Government of Puerto Rico
Public Service Regulatory Board
Puerto Rico Energy Bureau
World Plaza Building
268 Muñoz Rivera Ave,
San Juan, PR 00918

***Re: Comments on PREPA IRP Pre-Filing, In Re: REVIEW OF THE PUERTO RICO ELECTRIC POWER
AUTHORITY INTEGRATED RESOURCE PLAN, Case No. CEPR-AP-2018-0001***

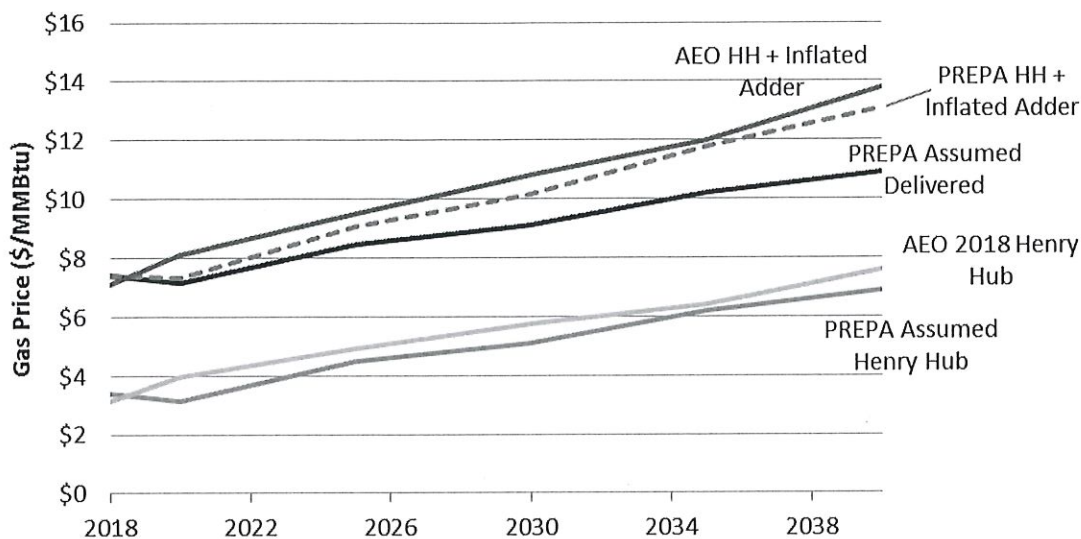
The outcome of this assumption is that gas is likely substantially underpriced in future years. As shown in the chart below, PREPA's assumed delivered gas price (black line) minus the \$4/MMBtu adder results in a Henry Hub price (gray) below that assumed by the Energy Information Administration's (EIA) Annual Energy Outlook (AEO) 2018 by about \$0.50/MMBtu (AEO forecast in light red). Adding the proper inflator to the LNG adder results in a gas price substantially higher than PREPA's base case (dotted red line), and even higher if the gas adder is applied to AEO's assumed baseline gas price (dark red) – on the order of \$1/MMBtu in 2020 and around \$2/MMBtu by 2030.

This error and assumption is substantial. A gas price differential of \$1/MMBtu translates to an energy cost differential of about \$6.5-8.0/MWh in 2020.

As one key example, in 2023, PREPA's assumed price is around \$8/MMBtu, which translates to an energy cost of ~\$60/MWh (assuming 7,000 MMBtu/MWh heat rate and \$3.5/MWh variable O&M). Using a correctly inflated adder and AEO's projections, a gas price of \$9/MMBtu would result in a gas energy cost of **\$66.5/MWh**, before capital or O&M costs for the gas port. In contrast, PREPA's solar price in 2023 of \$1,300/kW would result in a project of roughly **\$67/MWh** (not including Puerto Rico adders or federal subsidies). This result would suggest that relatively small differentials in gas price assumptions can make tremendous impacts in model choices.

- Vet the gas price assumptions and adders, adding inflation.
- Use consistent, non-speculative basis for the forecast of prices for natural gas imports, including source region.
- Ensure that any variable costs of delivery are appropriately incorporated into the gas price forecast for individual gas delivery options.
